Re: Tahmoor South Amended Project – Surface Water Impacts – Department of Planning, Industry & Environment Request for Information No. 1

Further to your email of 4 September, we have prepared the following responses to the above Request for Information (RFI) that relate to surface water issues for the Tahmoor South Amended Project.

Figure 2 Qualitative Risk to Pools in Dog Trap Creek

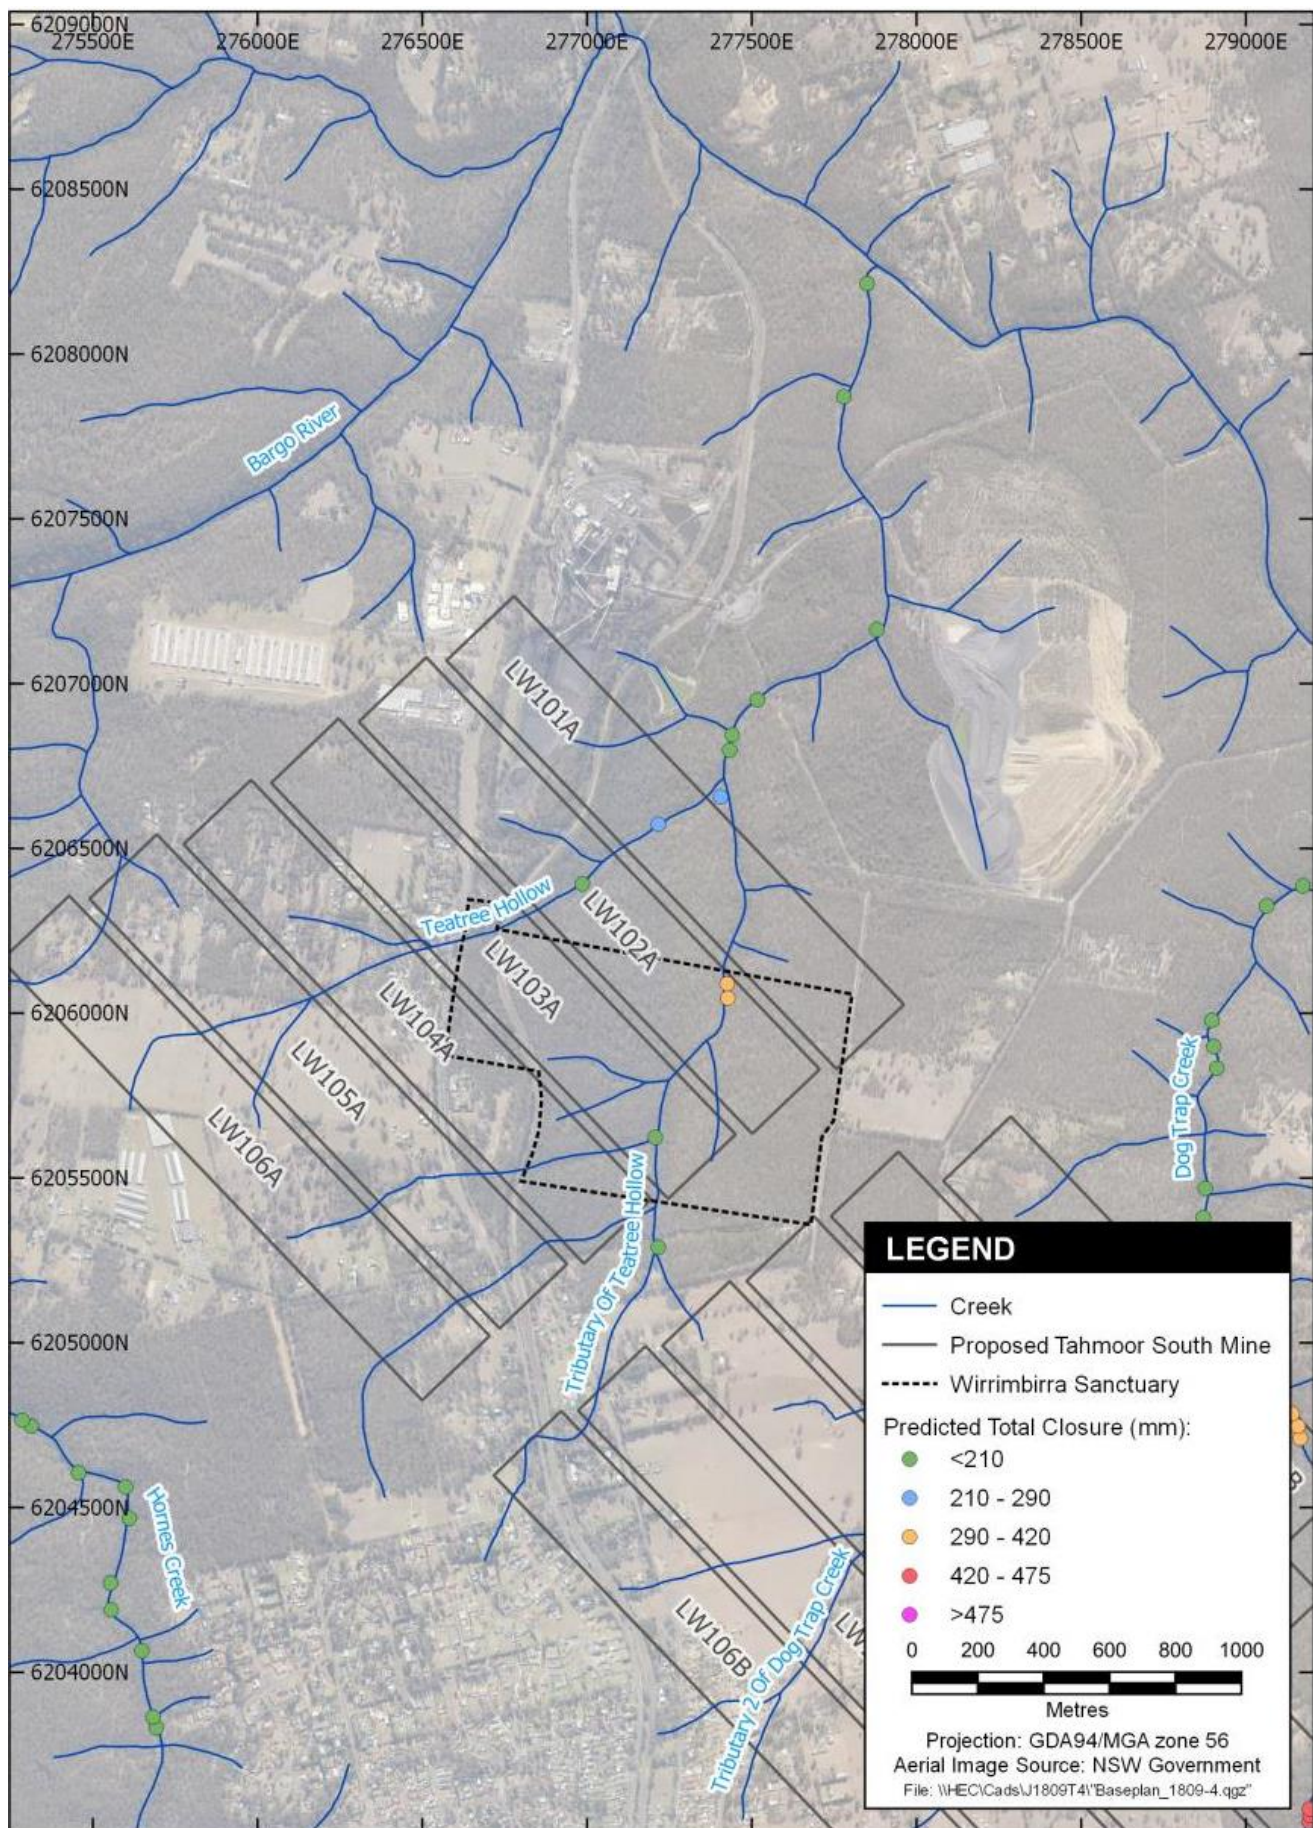
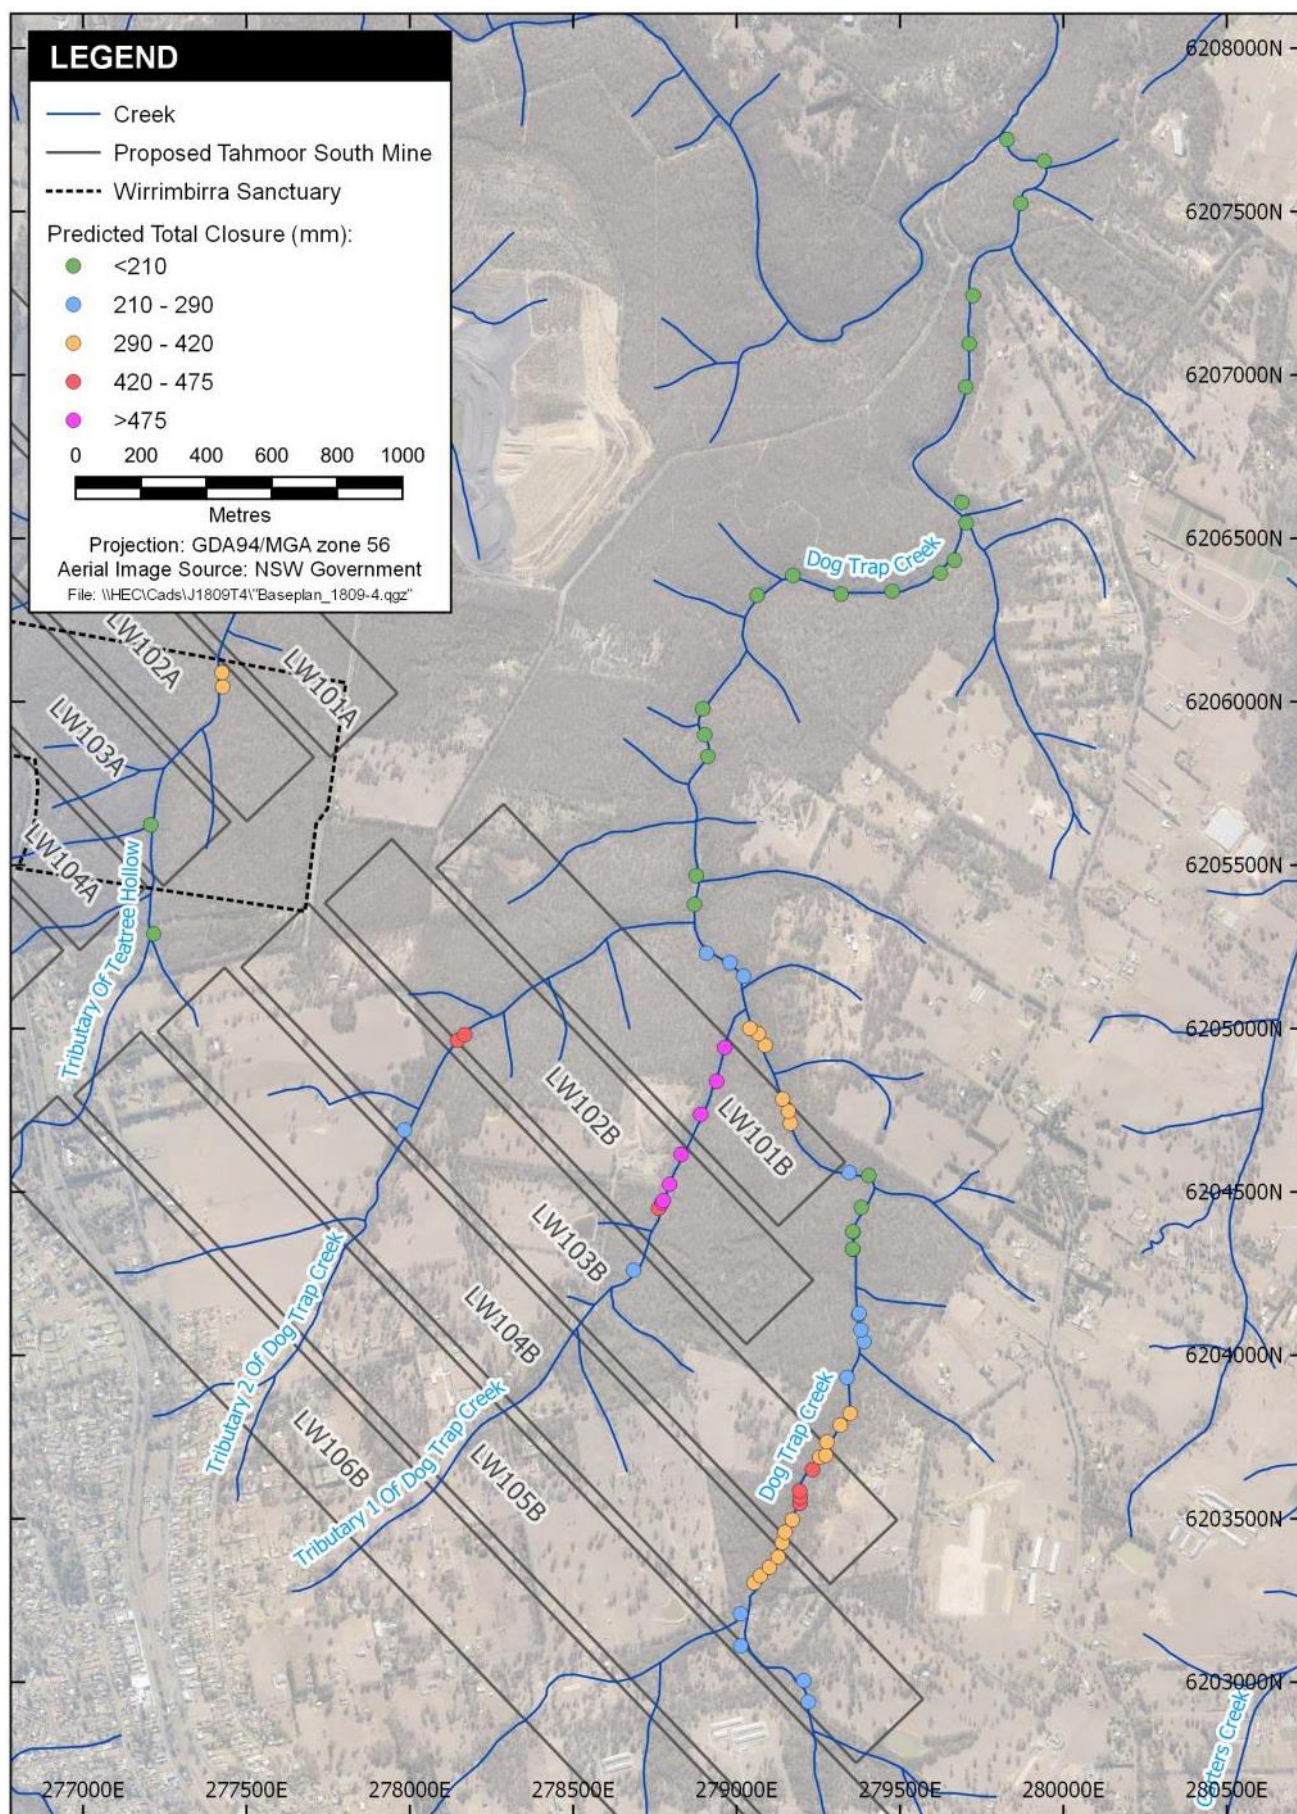
“Clarify the number and location of pools along Tea Tree Hollow, Tea Tree Hollow Tributary 1 and Dog Trap Creek that would potentially be impacted by the proposed development, including the likelihood of “Type 3” impacts to each pool. Note: the numbers referenced in Surface Water Impact Assessment (SWIA) (Section 6.2, Appendix D of the Amended Project Report) are incomplete/inconsistent (refer to table below).

Clarify the percentage of pools that are predicted to be impacted for valley closure greater than 475mm.

Updated Figures 36 and 37 of the SWIA to include all potentially impacted pools, as well as a location reference for Wirrimbirra Sanctuary.”

Figures 36 and 37 of the SWIA have been updated (expanded) to include all pools. These are given as Figure 1 and Figure 2 below. The table given in the RFI has been completed and is provided as Table 1 below.

There were eight pools mapped in Tea Tree Hollow and five pools mapped on the tributary of Tea Tree Hollow (refer Figure 1). Four of the pools mapped in the lower reaches of Tea Tree Hollow were more than 200 m north-east of LW101A and are therefore highly unlikely to be affected by subsidence-induced fracturing caused by the Tahmoor South Project. Therefore there are four pools mapped in Tea Tree Hollow that are upstream of a point 200 m north-east of LW101A. The predicted valley closure for three of these four pools mapped in Tea Tree Hollow and two of the five pools mapped on the tributary of Tea Tree Hollow is less than 210 mm, indicating that less than 10% of these pools are expected to be impacted. One pool on Tea Tree Hollow and one pool on the tributary of Tea Tree Hollow are predicted to have a total closure of less than 290 mm (less than 20% of pools are expected to be impacted). Two pools on the tributary of Tea Tree Hollow have a predicted total closure of 300 mm and 325 mm respectively. At this total closure prediction, less than 30% of pools are expected to be impacted.

The largest number of pools were mapped on Dog Trap Creek (refer Figure 2). Of these 53 were mapped upstream of a point 200 m north-east of LW101B (pools located further downstream are highly unlikely to be affected by subsidence-induced fracturing caused by the Tahmoor South Project). Six of these 53 pools are predicted to experience closure of less than 210 mm, indicating that less than 10% of these pools are expected to be impacted. Of the 53, 15 pools are predicted to experience total closure of less than 290 mm, indicating less than 20% of pools are expected to be impacted. Of the 53, 18 pools are predicted to experience total closure of less than 420 mm, indicating less than 30% of pools are expected to be impacted. Seven of the 53 pools are predicted to experience closure of less than 475 mm, indicating that less than 40% of these pools are expected to be impacted. The remaining seven of the 53 pools are predicted to experience total closure of more than 475 mm, indicating that more than 40% of these pools are expected to be impacted.

Figure 3 Streamflow – Redbank Creek Site R11 during Mining of LW31

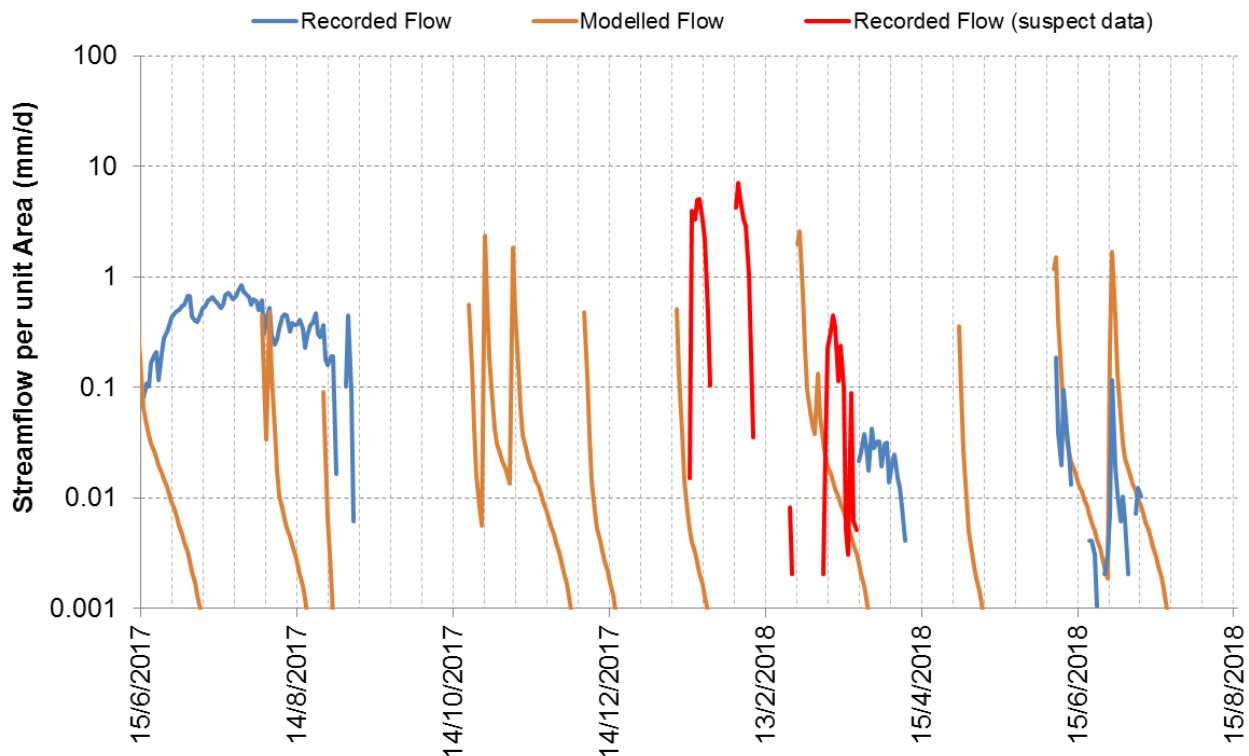
“Flows = 0 ML/d majority of the time while LW31 was being mined. Model says there should have been flows”. It is presumed that the first reference to “flows” refers to recorded flows at Redbank Creek Site R11.

We have consulted with the organisation who maintain the station (Hydrometric Consulting Services Pty Ltd – HCS). The station logger was identified as being potentially defective in late 2017, with the logger eventually replaced in March 2018. The period of suspect data is highlighted in the hydrograph shown in Figure 3 below. The period highlighted in red corresponds to the period from 15 January to 21 March 2018 inclusive. This 64 day period corresponds to 1.8% of the total data period.

If this period of flow is excluded, the total recorded flow for the period of mining of LW31 is approximately 164 ML compared with a modelled volume of 86 ML.

Figure 5 Modelled and Recorded Streamflow - Redbank Creek Site R11 - 2014

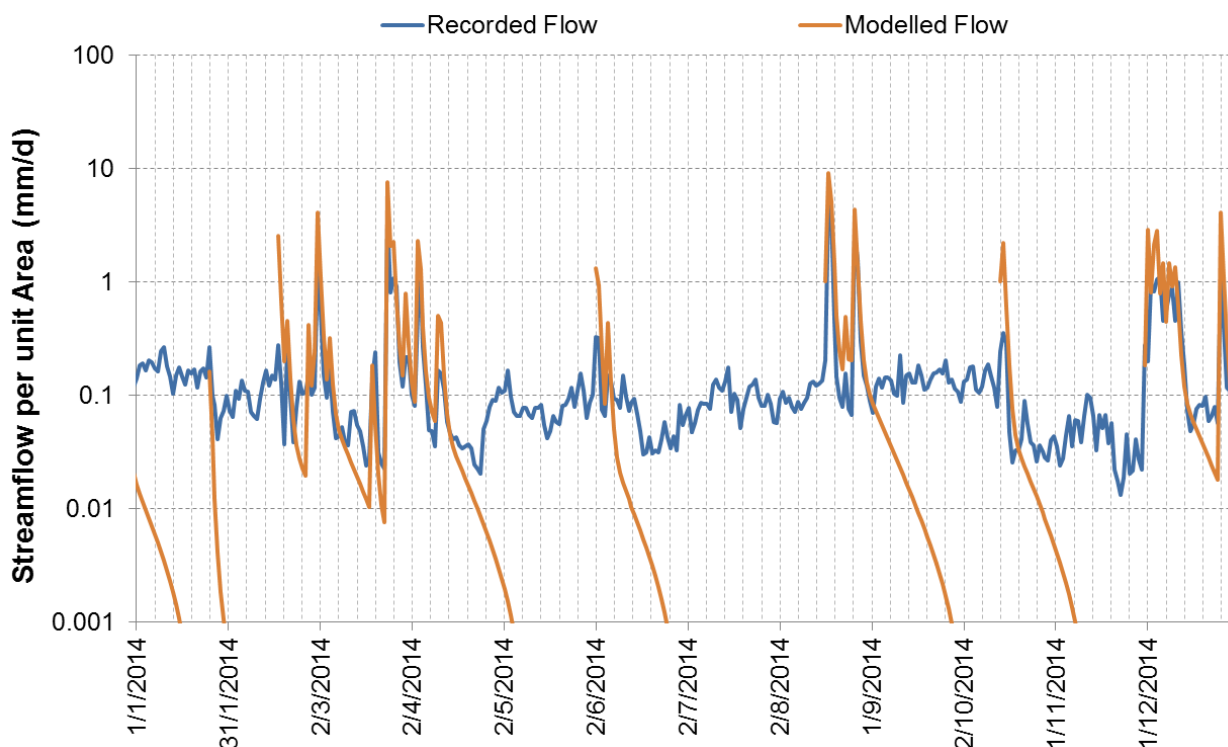
“Model predicts much lower flows than what is measured”. It is assumed that this refers again to Redbank Creek Site R11.

This assertion is not borne out by the total flows plotted Figure 4 above. It is difficult to discern the modelled and recorded daily flow data in the graphs presented in this slide because they are plotted as points. The data in one of the plots presented (excluding the recorded data for GS 212053) for the 2014 calendar year is reproduced in Figure 5 below.

As discussed in the SWIA report, the above hydrograph demonstrates a clear change in the low flow regime compared with earlier years (upon which the model calibration was based), with the modelled high flow events mostly exceeding recorded flow peaks but with a persistent baseflow component. The model is not meant to replicate the previous flow patterns during this period when an impact to the catchment flow regime is apparent. The model was calibrated for the period up to the end of LW26 (11 October 2012). The data in Figure 5 and the majority of the plots shown on Slide 9 show the ‘after’ impact period - when flow patterns had changed. Note that the total recorded flow for 2014 (Figure 5) was 350 ML while the modelled flow was 462 ML.

Figure 6 **Modelled and Recorded Monthly Streamflow - Redbank Creek Site R11 – Calibration Period**

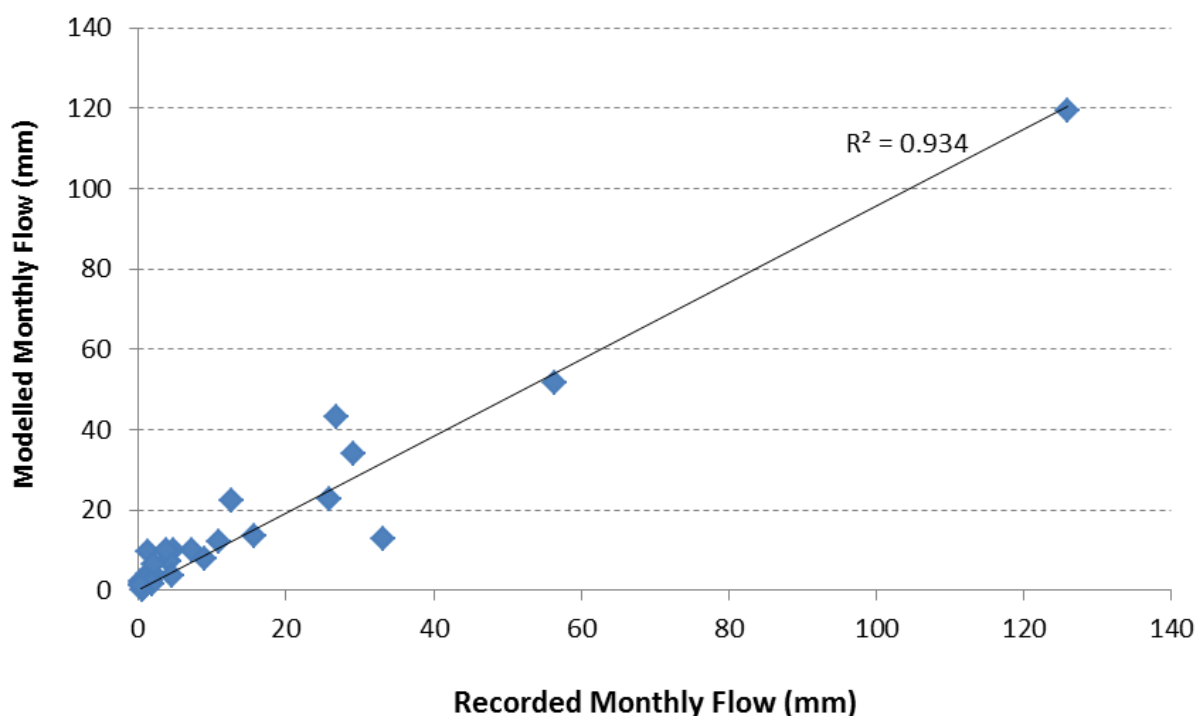
“Very poor correlation between Measured Flow and Modelled for R11”

It is not realistic to expect a catchment yield model to accurately replicate recorded flows on each day. Catchment response is dependent on rainfall temporal and spatial patterns. Temporally, if rainfall occurs in a burst in the late evening of a given day (as is typical in summer) the majority of the flow and the flow peak is unlikely to reach the gauging station until the next day and therefore there will be a significant disparity between rainfall and recorded flow on either day. Spatially, if a rainfall event occurs primarily near the edge of a catchment, runoff will take longer to reach the gauging station than it would if rainfall occurred near the station and again the flow peak may not occur until the next day.

It is unclear what period of data the plot in Slide 11 is for. As noted above the catchment yield model for Site R11 was calibrated for the period of mining of LW25 and LW26 and then used to assess the impact of mining on the flow regime in subsequent years. If the plots in Slide 11 are for the full data period, then a poor fit would be expected particularly given the issues with replicating flows on each day highlighted above. Figure 6 below shows a plot of modelled and recorded monthly streamflow for the period of calibration. This indicates a good calibration with a coefficient of determination of 0.934.

Figure 7 Flow Frequency Duration Plots – Redbank Creek Site R11 during Mining of LW25

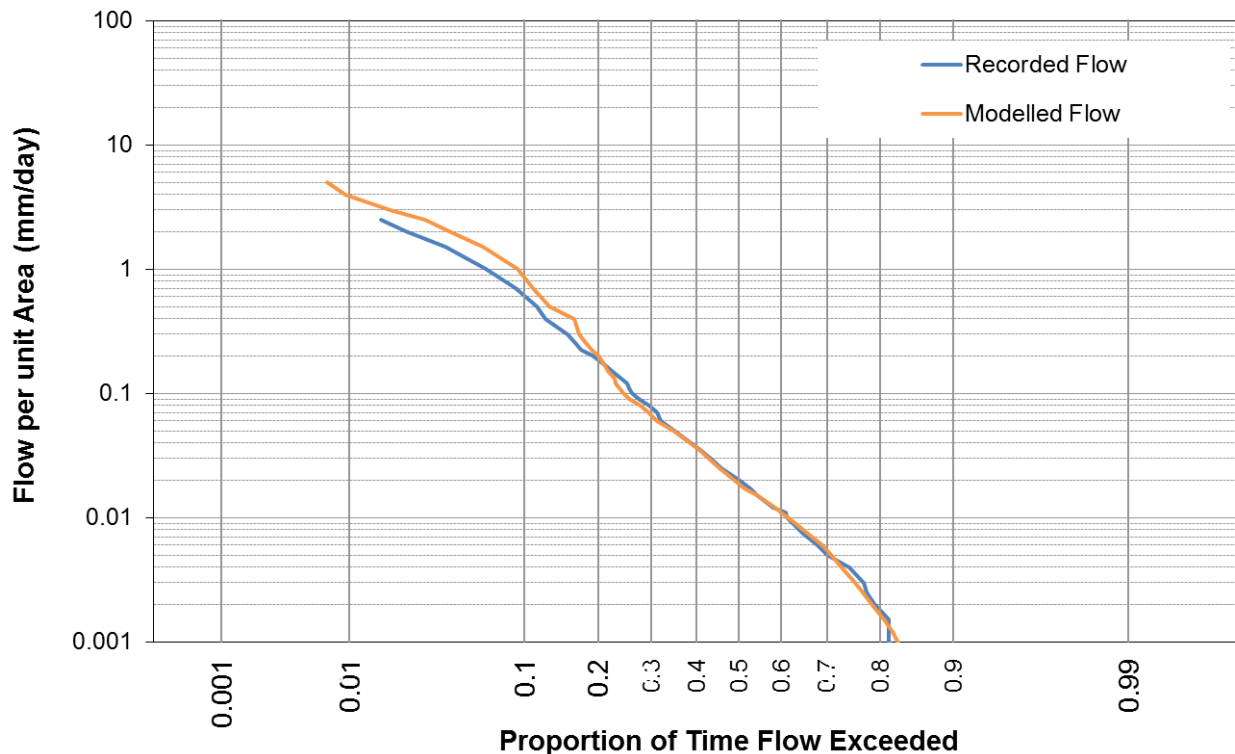
Flow exceedance curve presented indicating a mis-match between recorded and modelled flows in the range of flow less than about 1.2 ML/d.

It is assumed that this plot is for the full data period of 3,547 days. If so then a mis-match would be expected. As noted above the catchment yield model for Site R11 was calibrated for the period of mining of LW25 and LW26 and then used to assess the impact of mining on the flow regime in subsequent years. This is described in the SWIA report together with a series of flow duration curves which illustrate both the 'goodness of fit' for the calibration period, the change in catchment response

from the period of mining of LW27 (with greater prevalence of baseflow) and a second change in the flow regime during the mining of LW31, with the prevalence of baseflow diminishing and more ephemeral flow prevailing. The flow duration curve from the SWIA for the period of mining of LW25 (part of the period of model calibration) is reproduced below as Figure 7. This indicates a particularly good replication of low flows by the model for this period (consistent with the objective function of matching monitored to modelled low flow catchment yield). Subsequent flow duration curves given in the SWIA report illustrate the change in flow regime following the calibration period.
